MISSION REPORT / RAPPORT DE MISSION

Stonehenge, Avebury and Associated Sites (United Kingdom of Great Britain and Northern Ireland) (373bis)

31 January – 3 February 2017

# Report on the joint World Heritage Centre / ICOMOS Advisory Mission to Stonehenge, Avebury and Associated sites

**Fig. 6.4.3 - Western portal site at 1 to 30.000 - 2016 by Highways England**

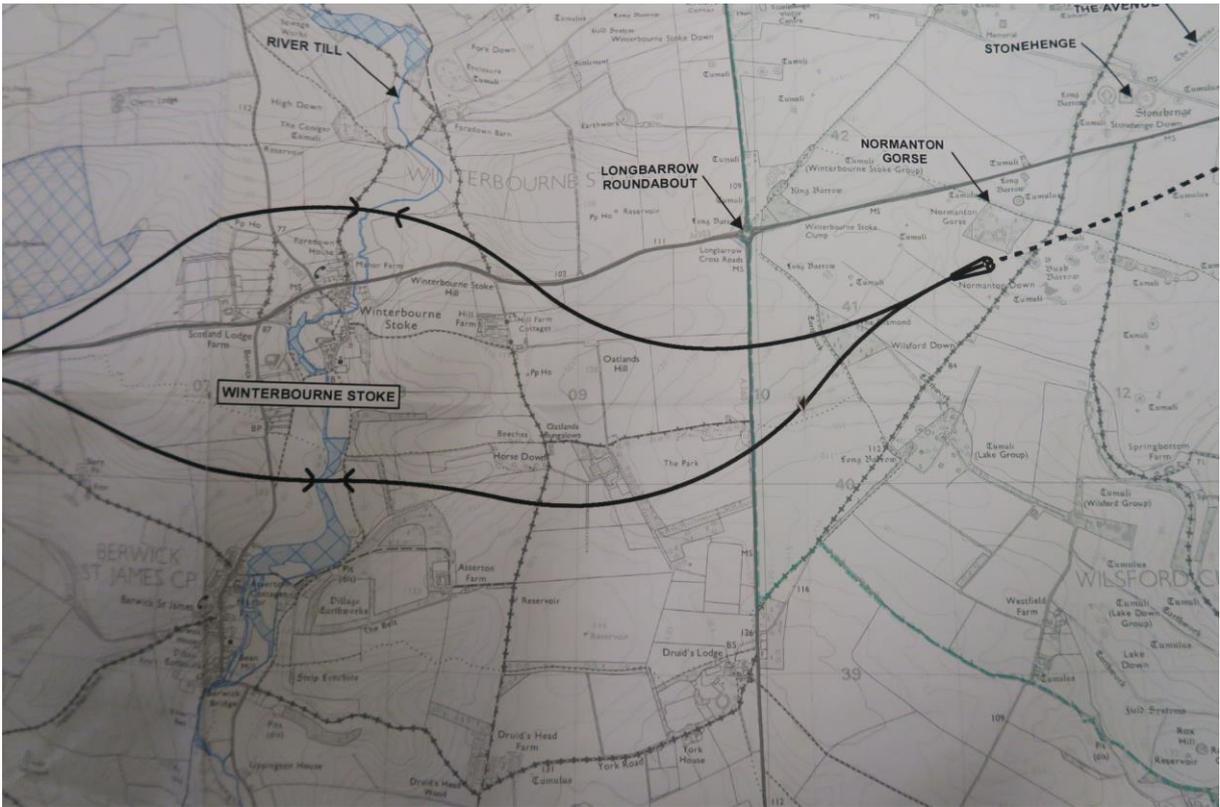
The first Advisory Mission commented on the difficulties of a Western portal being sited within the WH property. Given the importance of the overall archaeological landscape of the property, the tunnel portals and approach roads would be a major change that could have severe consequences to the OUV of property.

The SP and its heritage bodies will nonetheless need to remain particularly vigilant, as further decisions are taken and plans proceed, that a full heritage impact assessment is carried out in the area, and that both the portal and its access route and construction infrastructure have no adverse effect on heritage assets that contribute to OUV. This needs to be emphasised because the area to the east of the Avenue within the WH property contains several heritage assets, some well known such as Vespasian's Camp, others in the course of being investigated, such as Blick Mead (Mesolithic). Concerns about these heritage assets have already been expressed by respondents to the public consultation.
